PUBLIC INTEREST REVIEW FOR GROUNDWATER APPLICATIONS

TO: Water Rights Section Date August 12, 2025
 FROM: Groundwater Section J. Hackett
 Reviewer's Name
 SUBJECT: Application G- 18771 Supersedes review of March 12, 2019
 Date of Review(s)

A. GENERAL INFORMATION: Applicant's Name: Crum Ranch, LLC County: Gilliam

Figure 1. Well Location Map

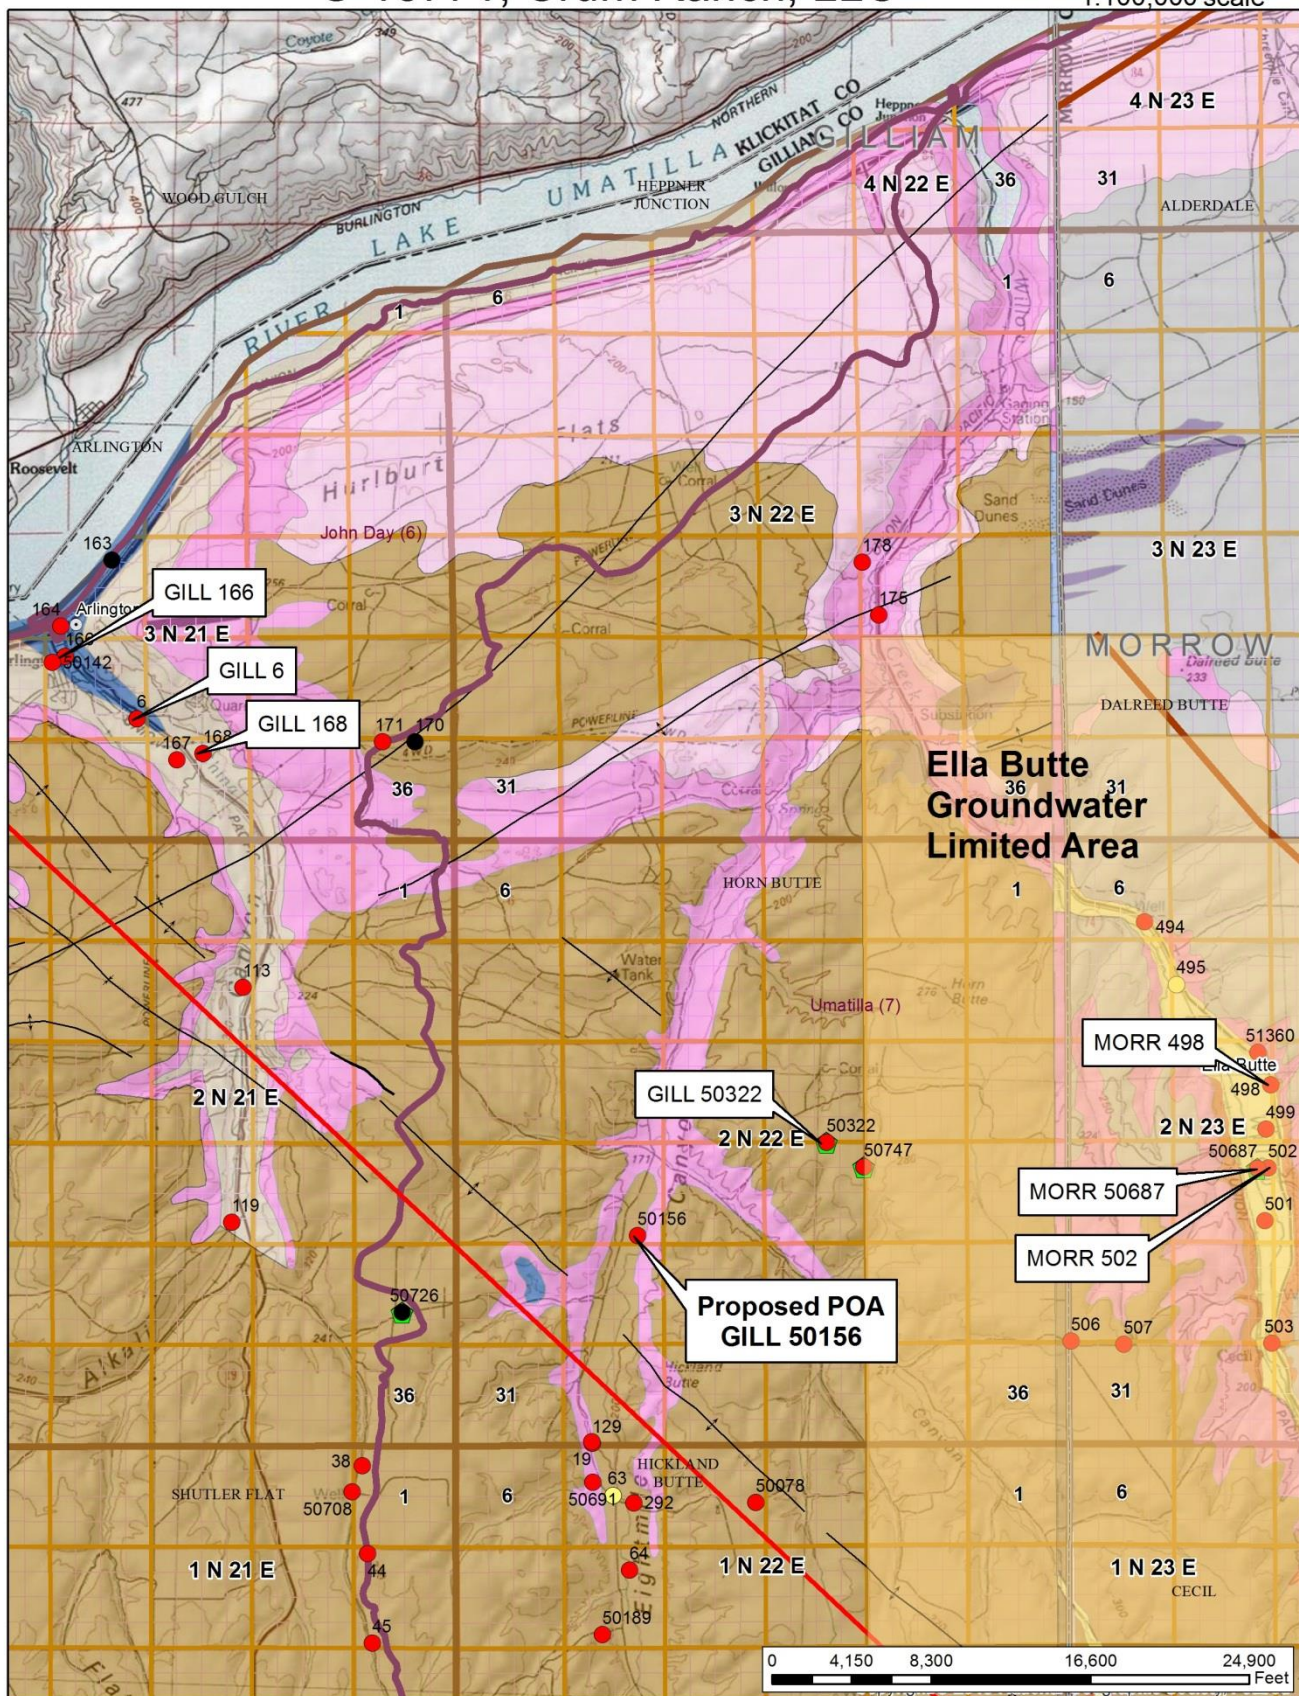
Long-term water level trends in nearby wells are presented in Figures 2 and 3. Well locations are shown in Figure 1. In the applicant's well, water levels have declined 14.7 feet since 2010 (rate of 1.6 feet per year) (Figure 2). (JTI, 8/15/25, updated look at GILL 50156 Hydrograph shows wls have declined 34.3 feet from 2010 to 2025, averaging 2.3 feet per year.) Water level elevations in the applicant's well are very similar to water levels in City of Arlington wells (Figure 2). Water levels in Arlington wells rose about 80 feet in the late 1960s in response to construction of the John Day Dam and consequent rise in elevation of the John Day pool behind the dam. Water levels remained stable from the late 1960s until the mid-2000s. Since the mid-2000s, however, water levels in these wells have declined by 15-20 feet, a rate of 1.5-2.0 feet per year (Figure 2).

Figure 2. Water-Level Elevation Trends in GILL 50156 and City of Arlington Wells

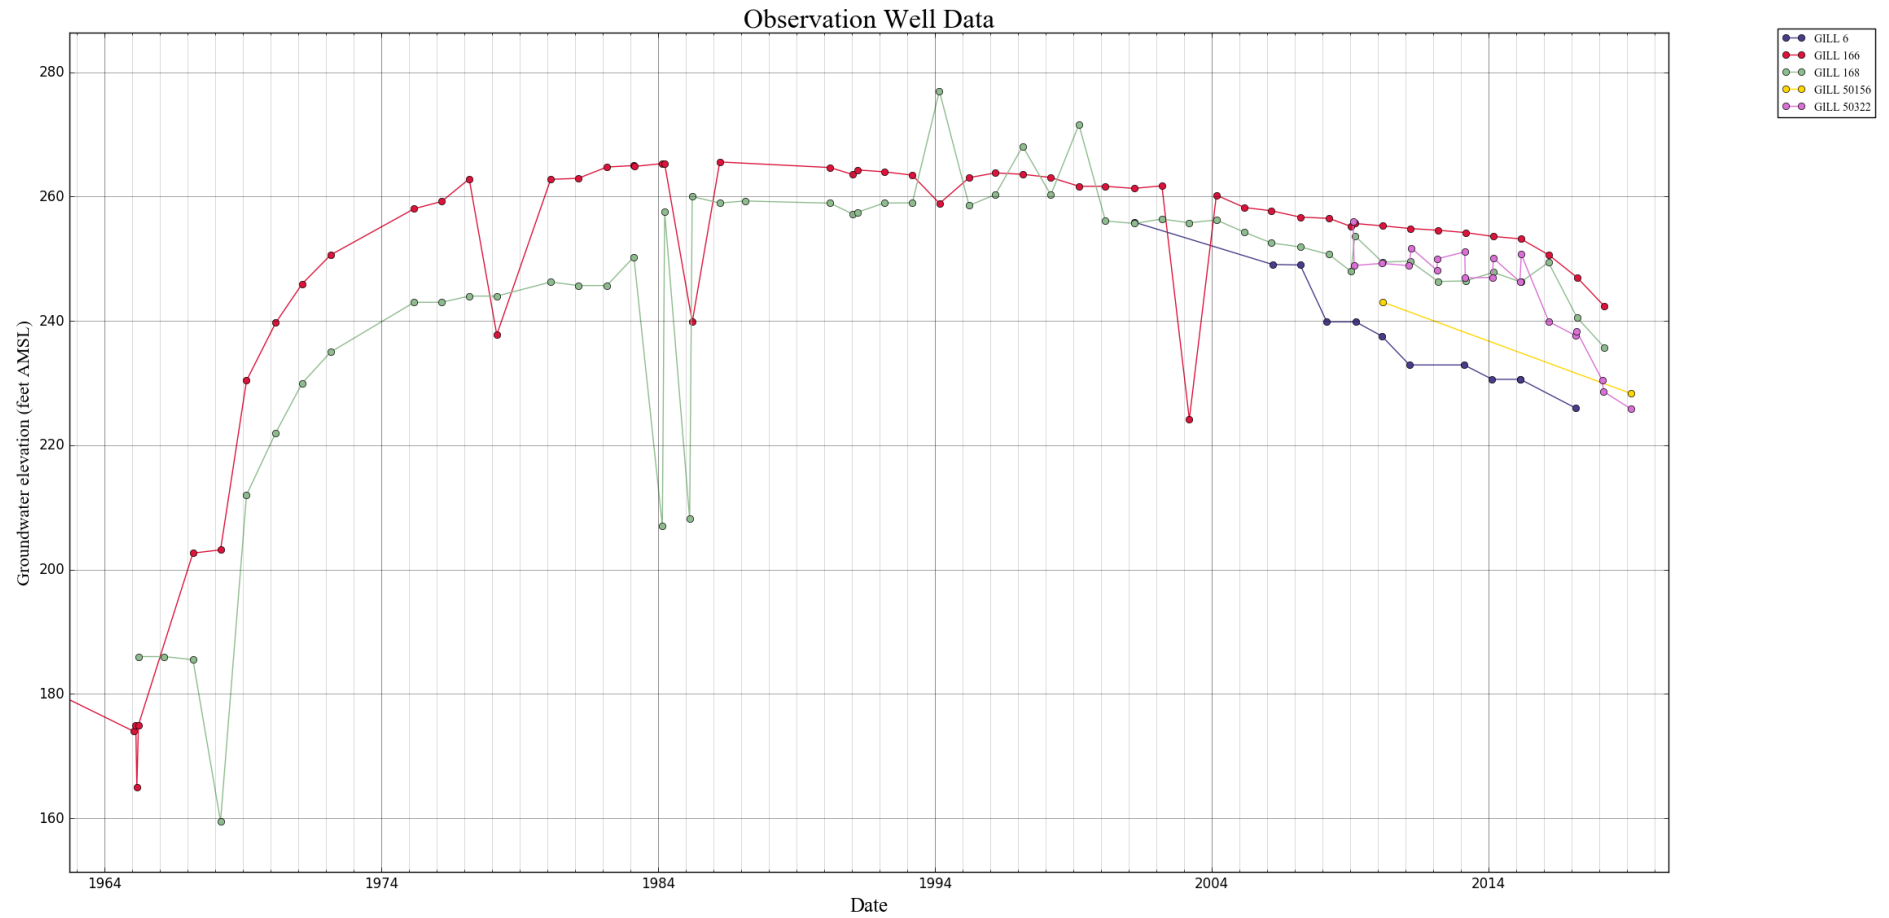
Similarities in elevations and trends between water levels in the applicant's well, City of Arlington wells, and select Ella Butte wells suggest they may produce from the same aquifer. Long-term water level declines in these wells also suggests the aquifer cannot support the additional use requested by this application.
